Environmental Review Team Report

Phelps Meadow Windsor, Connecticut

ENVIRONMENTAL REVIEW TEAM REPORT
ON
PHELPS MEADOW
WINDSOR, CONNECTICUT

The Eastern Connecticut Environmental Review Team was asked to prepare an environmental assessment for a proposed cluster subdivision in the Town of Windsor. The project site is approximately 85 acres in size and is located in the central section of the Town on Marshall Phelps Road. The Derekseth Corporation of Suffield are the developers for this project. Ed Lally and Associates have prepared the preliminary design proposal.

Preliminary Site Plan

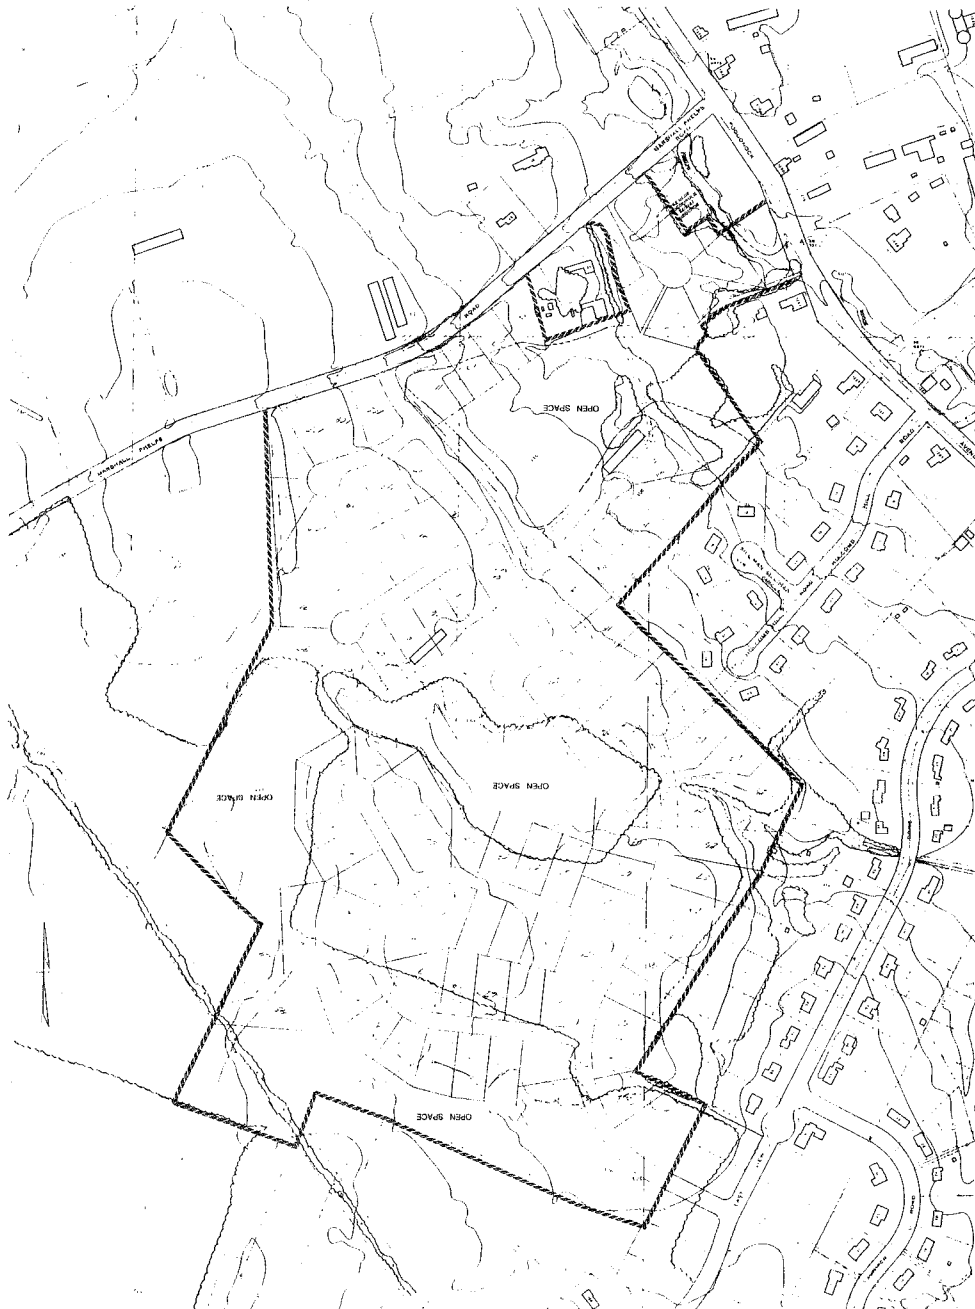
The plans for the development of this property call for a subdivision to occur in two stages, according to Ed Lally, the engineer and designer for the developer Derekseth Corporation. The preliminary plans which were reviewed show 105 lots, ranging from 1/3 to 1/2 acre each. A distributor access road crosses the site from Marshall Phelps Road on the north to East View Drive on the south and is the major spine from which some four cul de sacs and a loop road located at the southern end of the proposed subdivision plan will be constructed. A short cul de sac is also located off the loop road and it may provide needed access to the abutting property to the west. For the most part the cul de sacs are not lengthy and provide accommodations for approximately 7 to 12 lots. The area is served by public water and sewer lines. Open space areas are woven into the subdivision design and apparently will remain natural and undeveloped, being utilized as retention areas for surface water runoff.

Subsequent to the orientation meeting at the Town hall, a site inspection as well as a review of the Town's zoning regulations, subdivision standards and other documents, it appears that there is very little in the way of physical impediments or constraints which will hamper the development of this property as proposed by Derekseth Corporation. As noted earlier, open space, apparently a continuing concern of the community, has been woven into the plan. There appears to be no excessively steep topography on the site and the designer/engineer has noted there will be minimum cut and fill for street grades which will be somewhat moderate. The town Planning and Zoning Commission very recently carved this parcel of land from an Agricultural Zone to permit this proposed A.A. Zone cluster development, apparently in harmony with current residential development patterns in the surrounding area. The traveled portion of Marshall Phelps Road may require some future improvements, such as widening with the completion of this subdivision and the potential for additional development in this area of the Town. On the matter of streets the preliminary plan which was reviewed shows only one proposed street providing ingress and egress to the property which lies to the west of this proposal. It may be desirable, therefore, to consider additional street access points or perhaps walkways to the developable land to the west. Also it may be advisable to consider the possibility of a street connection from Holcomb Hill Road to the proposed distributor road, perhaps at least a paved walkway to connect the two areas.

It is noted that many of the proposed streets have an east-west orientation. This may be an opportunity to take advantage of southern exposures to the maximum and utilize solar access. The Town of Windsor has zoning regulations which require consideration by the developer of the use of passive solar energy techniques. Such regulations cover house orientation, street and lot layout, vegetation, natural and man-made topographic features, and protection of solar access within the development.

Drainage Areas

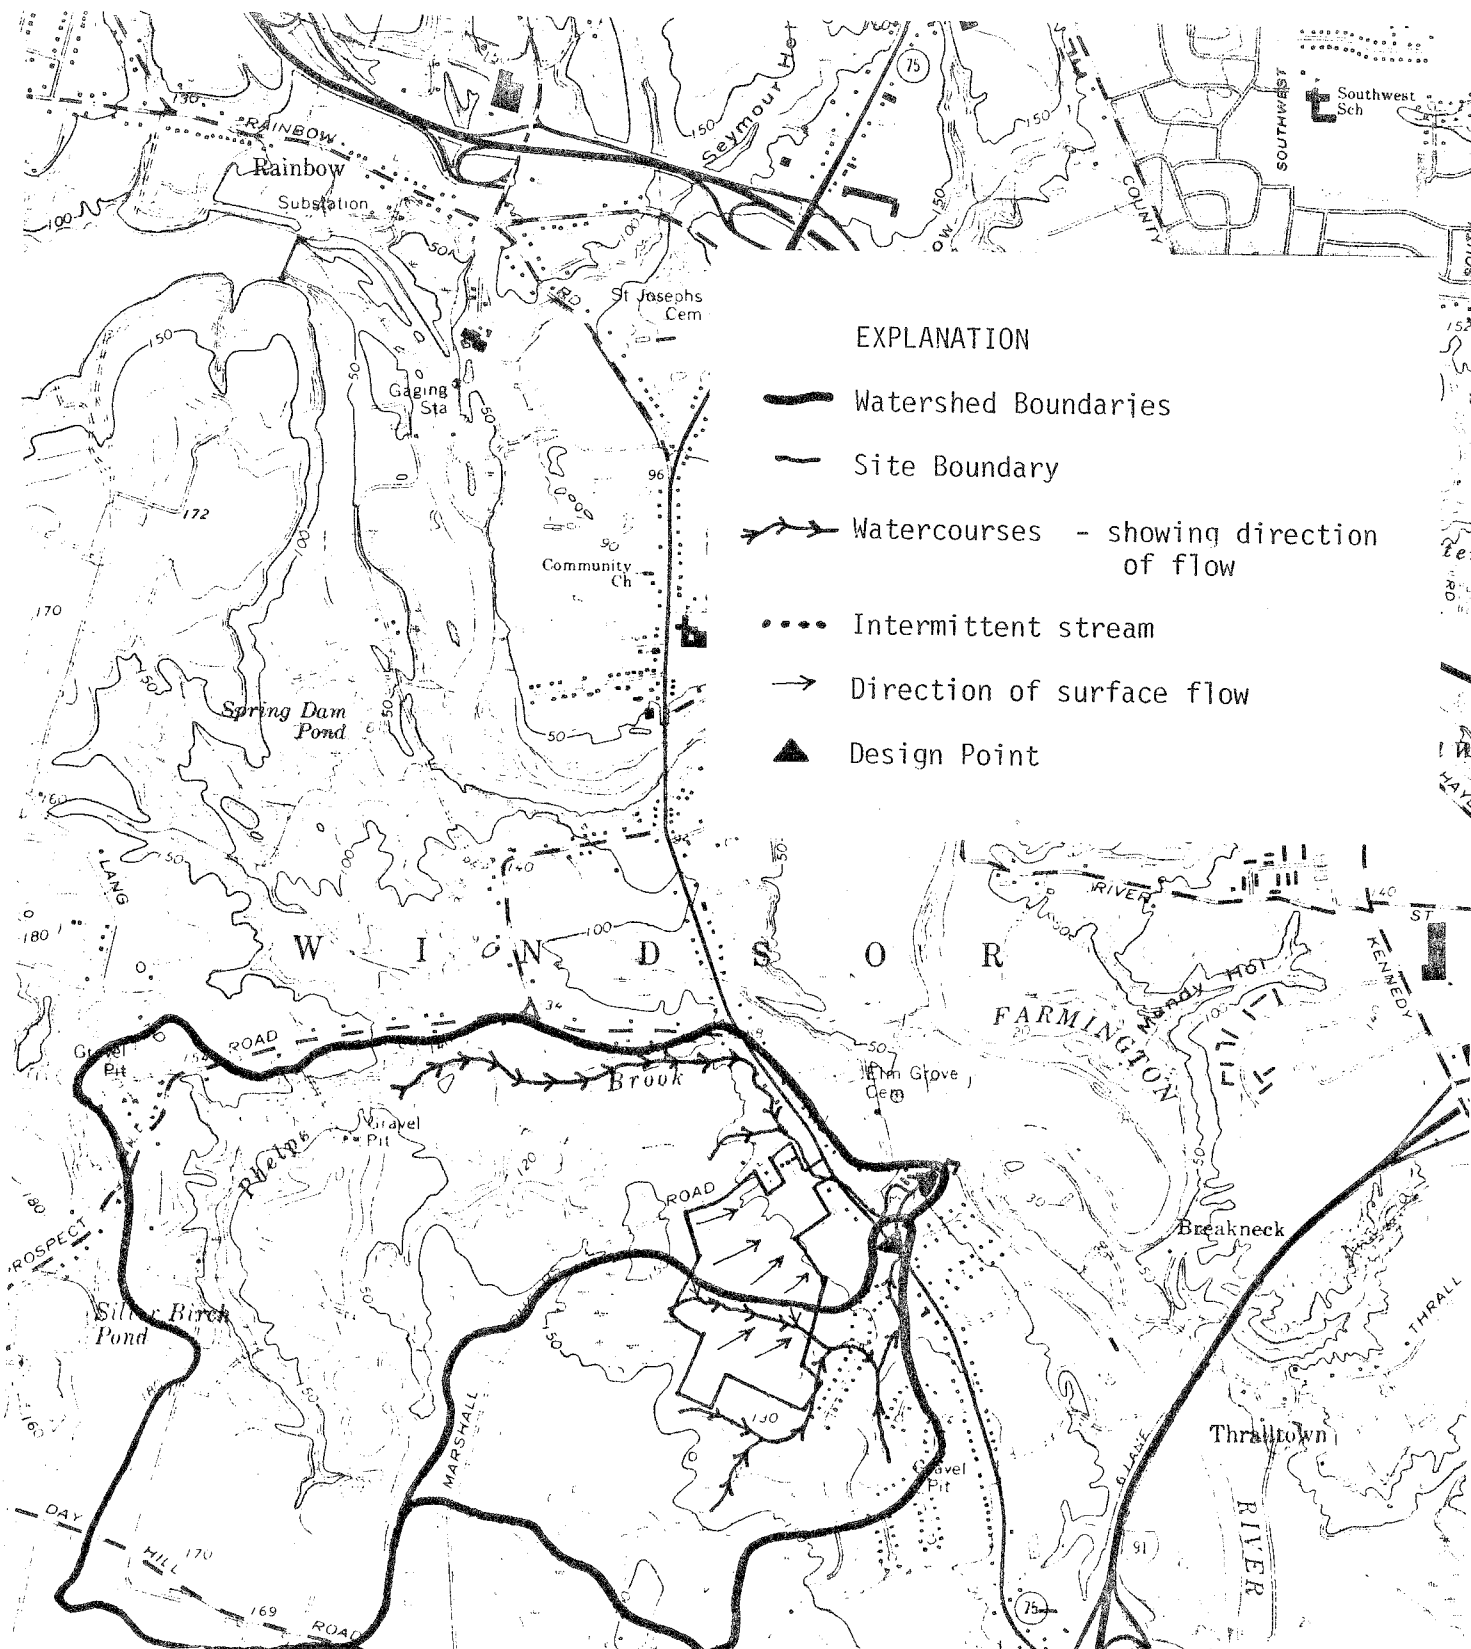
Runoff from the northern half of the site flows generally eastward into Phelps Brook, which parallels Route 75. The southern half of the property drains (See drainage area map.) into an unnamed, southeast flowing stream. This stream is tributary, to Phelps Brook, which in turn is tributary to the Farmington River.

Development as proposed would generate additional runoff from the site, causing an increase in peak flows in the brooks during periods of precipitation. These increases, which underscore the importance of a carefully designed stormwater management plan, would result largely from the removal of vegetation and from the covering of pervious soils by impermeable surfaces, such as rooftops and pavement, (i.e., roads, driveways, etc.). The added runoff could cause increased overland and stream-channel erosion and/or increase the peak flood flows of the stream on the property as well as Phelps Brook.

The developer has proposed a storm drainage management system for only Phase I of the Phelps Meadow Subdivision. A storm drainage management plan for Phase II of the Phelps Meadow Subdivision was not available for review by Team members at this time. Therefore, the following comments are directed primarily at the proposed storm drainage management plan for Phase I. Prior to the approval of a Phase II development plan, it is recommended that the applicant be required to submit detailed hydrological information on pre- and post-development runoff volume and peak flows from this second section of the property. Estimates should be provided for a 10, 25, 50 and 100 year design storm. Detailed design specifications for all stormwater control facilities (including ponds) should also be submitted.
